**PROPOSED SOCIAL WELFARE FACILITY (RESIDENTIAL CARE HOME FOR PERSONS WITH
DISABILITIES) IN "VILLAGE TYPE DEVELOPMENT" ZONE ON APPROVED NAM SANG WAI
OUTLINE ZONING PLAN NO. S/YL-NSW/10 AT LOTS 3669 S.A RP (PART), 3669 S.B RP (PART),
3670 RP (PART) AND ADJOINING GOVERNMENT LAND IN D.D.104, NAM SANG WAI, YUEN LONG**

Town Planning Application No. A/YL-NSW/348 - Submission of Further Information (4)

Response-to-Comment Table

**PROPOSED TERMINAL MANHOLE AND
CONNECTION**

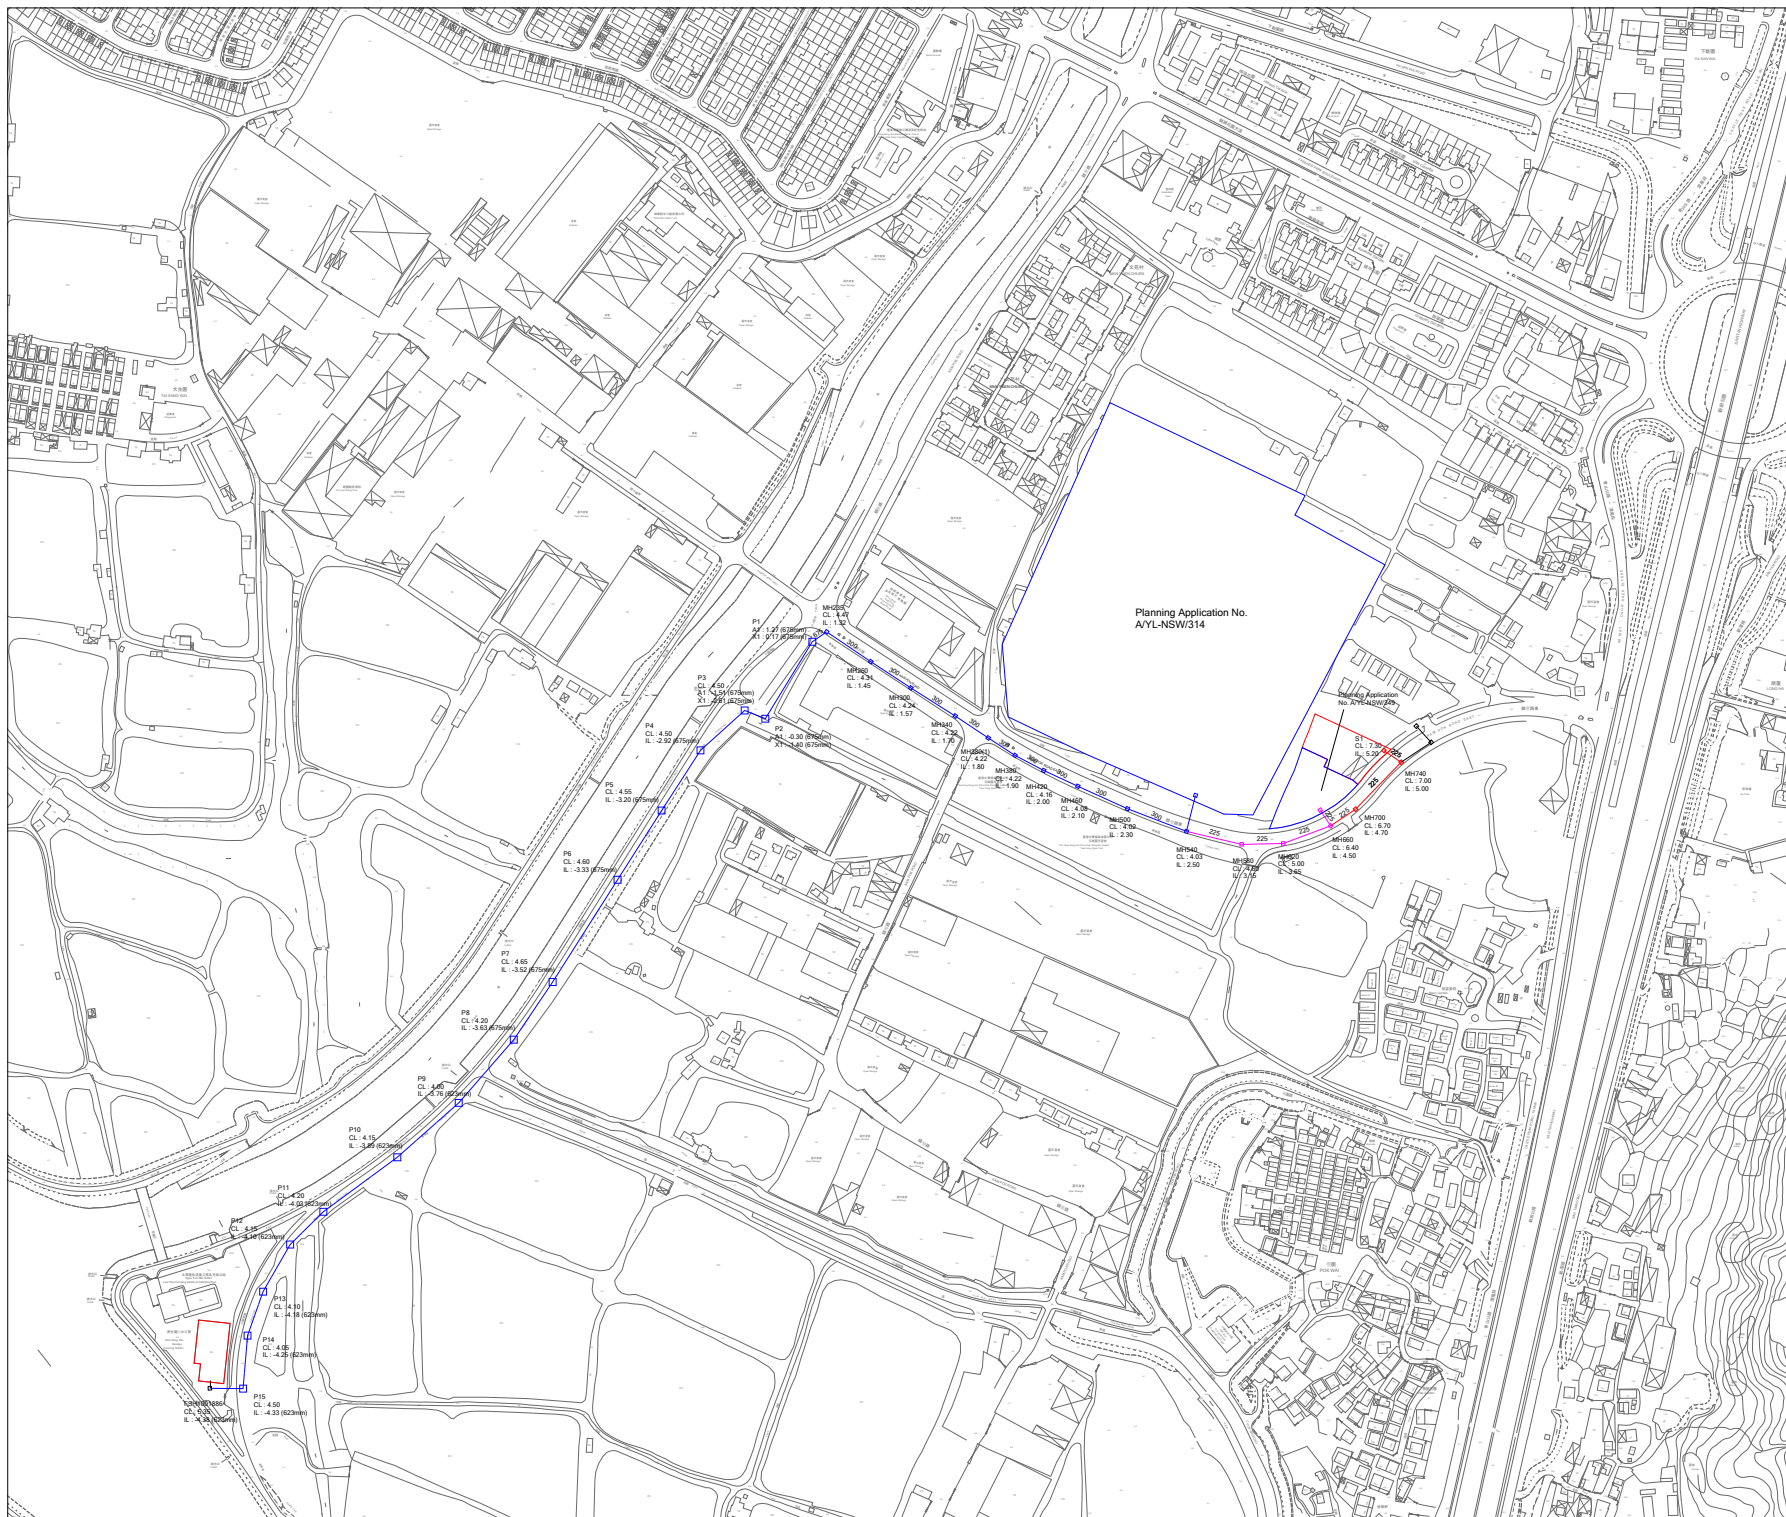
and adopt a conservative approach for the pipe diameter in the hydraulic assessment.	
4. Section 2.4.1 – a. Please revise as “New terminal manhole (namely S1) and manholes MH700 and MH740 will be constructed to collect..” b. Please revise “connect to the communal sewer” as “connect to MH660”.	The Section is revised accordingly.

- 2.4.1. New terminal manhole (namely S1) and manholes MH700 and MH740 will be constructed to collect the sewage generated from the Proposed Development and connect to manhole MH660 via a new 225mm diameter sewer pipe. The location of the proposed connection are shown in **Figure 3**. The cover level of proposed terminal manhole should be higher than that of the downstream public manhole(s). The proposed new terminal manhole and 225mm sewer pipe within site boundary will be implemented and maintained by the Project Proponent, other proposed manhole and sewer outside site boundary will become a public sewage system serving multiple users and will be handed over to government for future maintenance. The capacity
